FutureGen's Response to
Informal Request # 3

From: Gilmore, Tyler J [Tyler.Gilmore@pnnl.gov]
nt: Friday, January 17, 2014 4:06 PM
): McDonald, Jeffrey
Cc: Greenhagen, Andrew
Subject: Re: Informal Request (IR) # 3 (IR3-01-10-14)
Attachments: EPA_IR3_for_FG-RPT-017-Final.pdf

01-10-2014: Email from Jeff McDonald (U.S. EPA Region 5) to Tyler Gilmore (Alliance). Informal Request (IR) #3 (IR3_01_10_14)				
Requests based on the text application				
IR #	Subject	Page	Doc. Sec.	Par.
01-10-2014_1	Alternative PISC timeframe	7.1	7.0	<p>"It appears that FutureGen will not be making a demonstration for an alternative PISC period (other than the 50 year default). We assume that if FutureGen makes a demonstration for a PISC other than the 50 year default, this will happen in the future. Is this correct?"</p>
01-10-2014_2	Testing and Monitoring	5.25	5.2.3.3	<p>"This bullet point states that pressure gauges will be pulled and recalibrated during a well workover, when the injection and monitoring well tubing is pulled. Question: Is this frequency of pressure monitor calibration adequate? How often does FutureGen anticipate it will pull the tubing of the well? We think that redundant gauges should

Determination of the Top of the Injection Zone, based on Geophysical Logs and Modeling Results

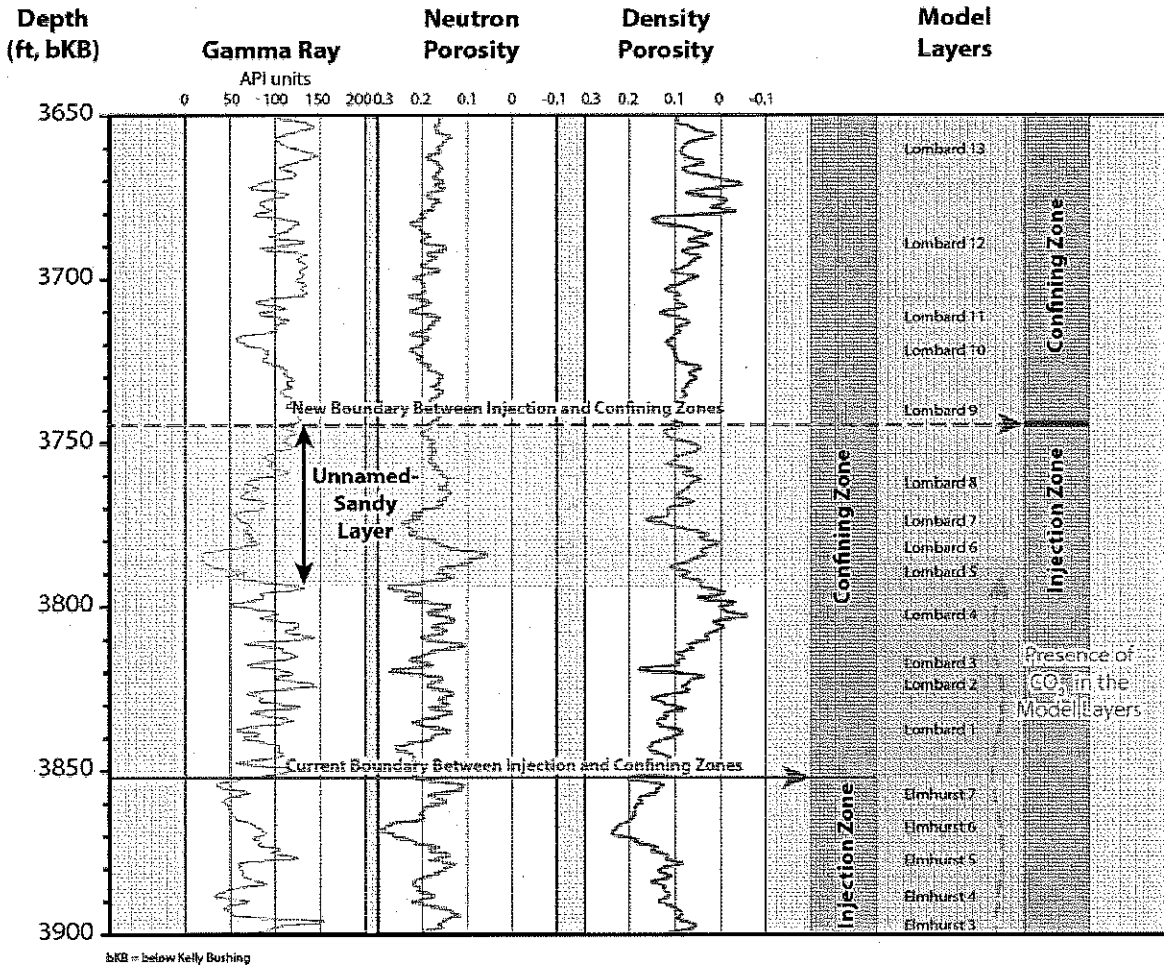
01-10-2014 Email from Jeff McDonald (U.S. EPA Region 5) to Tyler Gilmore (Alliances): "Informal Request (IR) #3 (IR3_01_10_14)"		FutureGen Response		Footnote / Reference Citation	
IR #	Subject	Page	Doc. Sec. Par.	EPA Comment / Question / Request	FutureGen Response
01-10-2014_5	PISC	3.27 to 3.34	7.1.3 and 3.1.6	"The computational model results indicate that a small fraction of the injected CO ₂ will enter the lower part of the Lombard formation. If authorized under any UIC permits, the injection zone will need to include that lower part of the Lombard. Please determine what members or submembers of the Lombard are expected to receive CO ₂ and will therefore be part of any permitted injection zone."	The computation model results indicate that the Model Layer "Lombard 5" is the top unit containing a fraction of injected CO ₂ during the 100-year simulation. However, because geophysical logs indicate the presence of an unnamed thin sandy layer above Lombard 5 (see graphic in Appendix A), the Alliance determined that this thin sandstone should also be part of the injection zone. In conclusion, based on the current knowledge of the geology at the FGA1 stratigraphic well, the top of the injection zone is set at 3,745 ft KB (or 3,731 ft below ground surface), which is in the lower part of the model layer "Lombard 5" (Appendix A). KB = below Kelly Bushing

Figure 2. Updated and Revised Plan for Monitoring Wells.

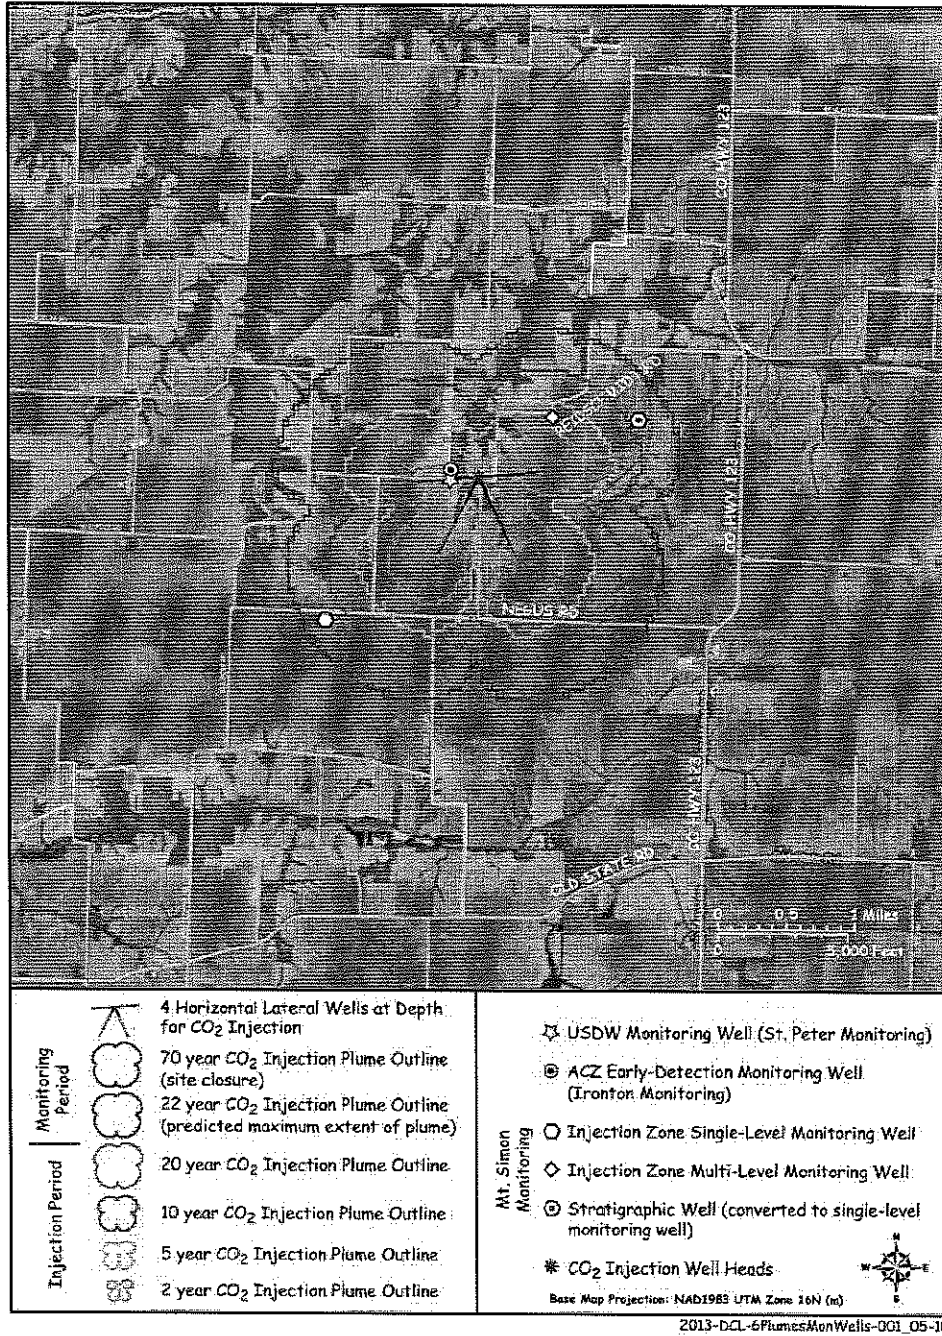
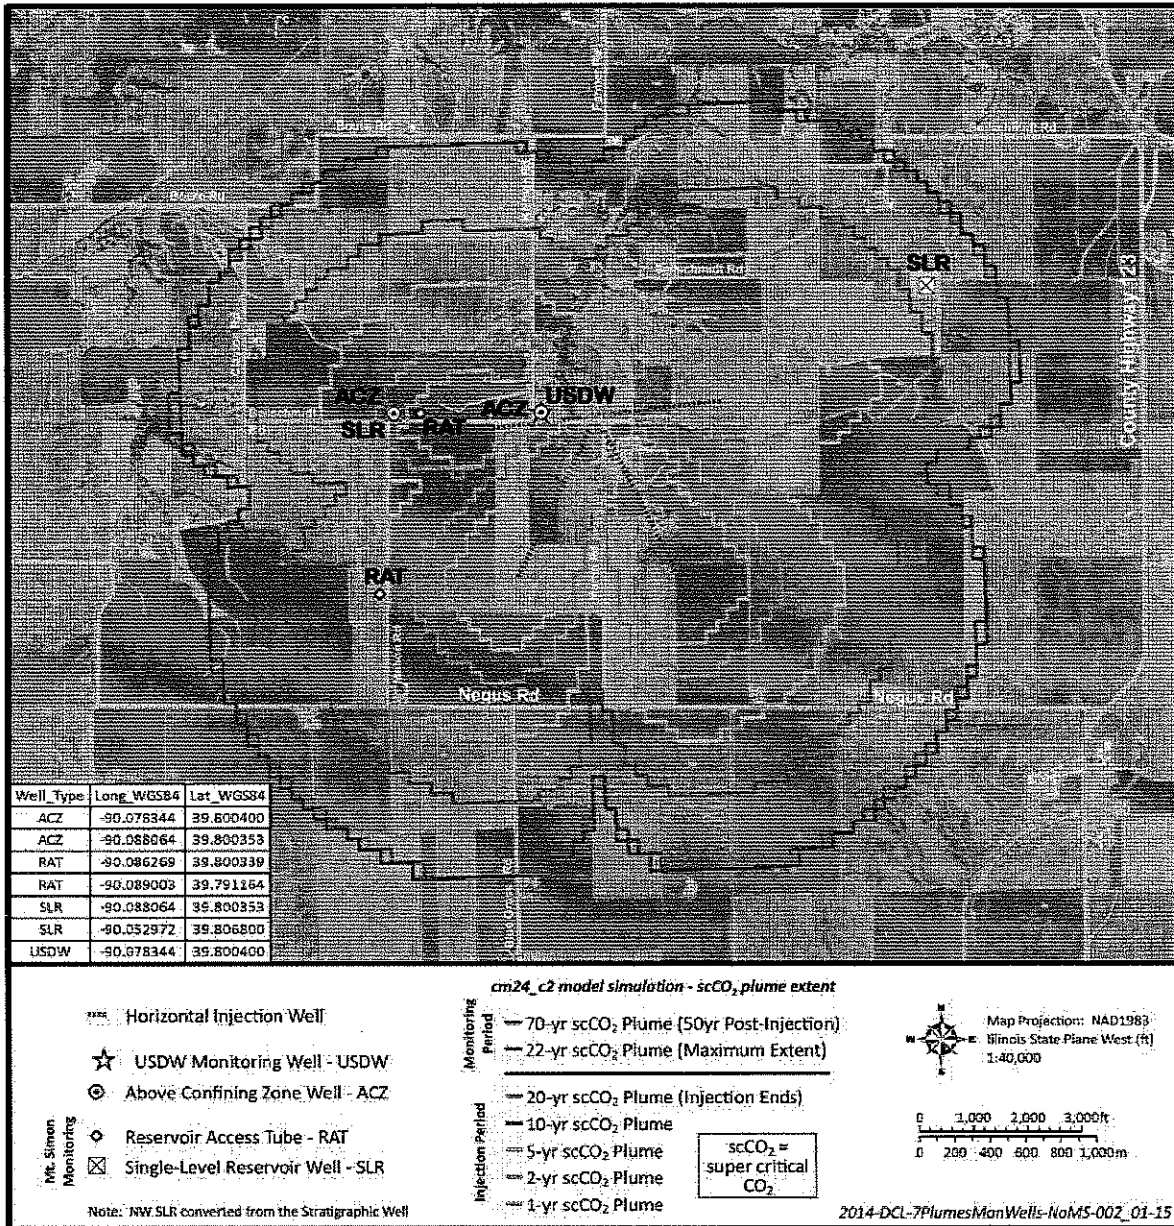
01-10-2014_6	PISC and T&M	7.5	7.2 and 5.2	"Specific locations of monitoring wells need to be identified for any permit decision including what specific parameters will be monitored for."	The Alliance has modified the monitoring network design since the UIC permit application was submitted. A discussion, which includes monitored parameters, and a location map showing the updated and revised monitoring well network are provided in Appendix B.
01-10-2014_7	PISC and T&M	7.5	7.2.2	"Please state whether FGA will use a "multi-level monitoring system within a single casing string with multiple sample intervals" or a "multi-level piezometer installation.""	The Alliance has modified the monitoring network design since the UIC permit application was submitted by eliminating this "multi-level monitoring well". The previously planned multi-level completion has been replaced by two fully cased reservoir access tubes (RATs) that will be installed within the boundaries of the simulated 5-year CO ₂ plume. The RATs will extend to the base of the reservoir and into the Precambrian bedrock. The RATs will be non-perforated, cemented casings used to monitor CO ₂ arrival and quantify saturation levels via downhole pulsed-neutron capture (PNC) geophysical logging across the reservoir and confining zone. A discussion and location map showing the updated and revised monitoring well network is provided in Appendix B.

As part of the project's design optimization, the monitoring well network design has been revised (Figure 2) to increase its effectiveness, simplify its engineering design, and hopefully eliminate any permitting challenges that might have been associated with the MLR. The revisions include eliminating the MLR well in favor of adding two fully cased reservoir access tube (RAT) wells. The revised design includes a total of seven monitoring wells summarized in Table 1 and as follows:

The most recent monitoring well design includes five deep monitoring wells and two RAT wells as listed in Table 1.
